STAFF RECOMMENDATION

NCPC File No. 6597

VIETNAM VETERANS MEMORIAL VISITOR CENTER Approval of Site Selection and Design Guidelines

July 27, 2006

Proposal to raise grade of existing site for underground building

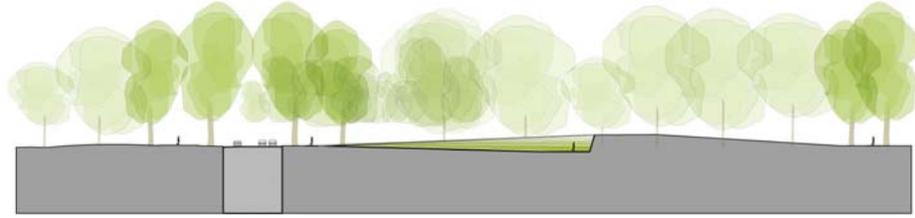
Staff Analysis:

Upon receipt of the submission materials, staff asked the applicant to further clarify the meaning of this proposed design guideline. Staff asked the applicant to indicate at what point the site was likely to be raised as much as 10 feet above grade, and the applicant indicated that it is too early in the design phase to provide such information. Because it is unclear what effect this design guideline would have on the existing site, including the affect upon views to and from the Lincoln and Vietnam Veterans Memorials that could result in interference with or encroachment upon existing memorials, staff is unable to recommend this design guideline to the Commission. Staff is recommending instead that the applicant use the existing site grade as much as possible during design development of this underground building. Instead, staff recommends NCPC design guideline #3.

3. To maintain the character of the historic landscape, the Visitor Center's design concept will be based on maintaining the existing grade, and any new slopes will be gradual. The project will raise the existing site grade only to allow for an accessible entry ramp.

Proposed entry ramp concept with raised grade of existing site

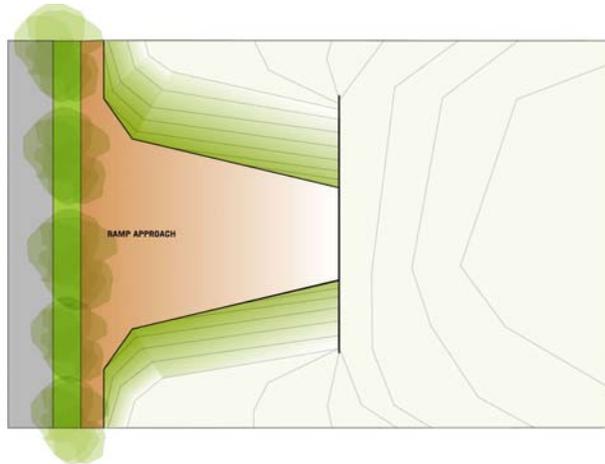
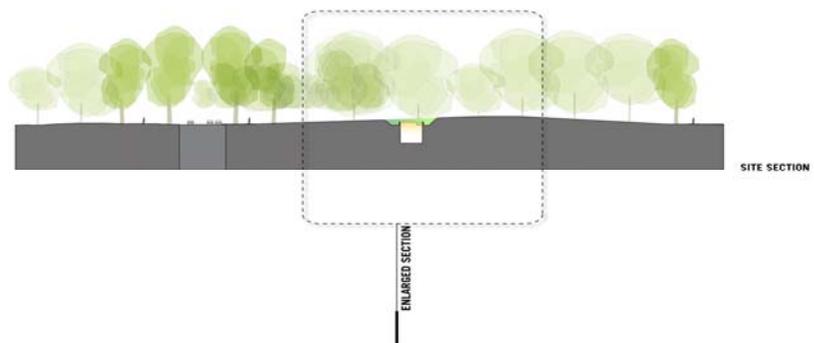
Staff Analysis:

Staff is concerned that such a downward slope may result in adverse effects upon the historic nature of Site A and interfere with and encroach upon views to and from both the Lincoln and Vietnam Veterans Memorials. Staff is recommending that the Commission approve Site A with design guidelines that address the potential impacts that entering the Visitor Center "via a gradual downward slope" might otherwise have upon the site. Instead, staff recommends NCPC design guidelines #1, 2, 3, 6, 7, and 11.

Site Section showing proposed roof opening

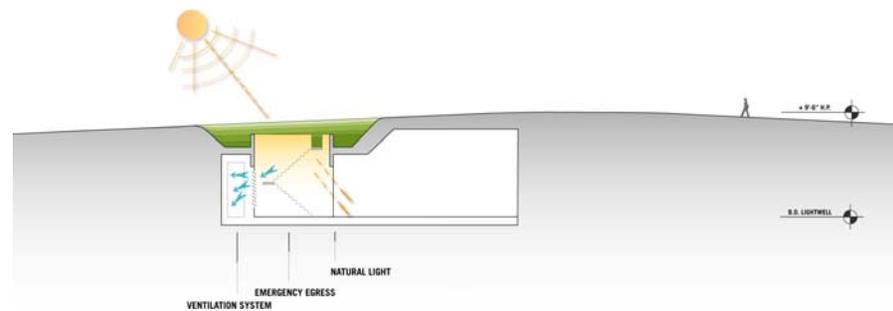
Staff Analysis:

Staff concurs with the applicant's determination to minimize penetrations for vertical structures above the finished grade of the site, but notes that the design for the building has not yet been sufficiently documented for staff to concur with the specific design approach proposed. Staff is therefore recommending that modifications to the existing site grade be kept to a minimum and that any building elements that penetrate or are visible through the ground plane be designed to avoid interference with or encroachment upon views to and from the Lincoln and Vietnam Veterans Memorials. Instead, staff recommends NCPC design guidelines #1, 2, 3, 4, 5, 6, and 14.

5. The Visitor Center will not intrude into the landscape. No protrusions, such as skylights, monitors, light wells, or sunken areaways, will be visible from the sidewalk surrounding the site.
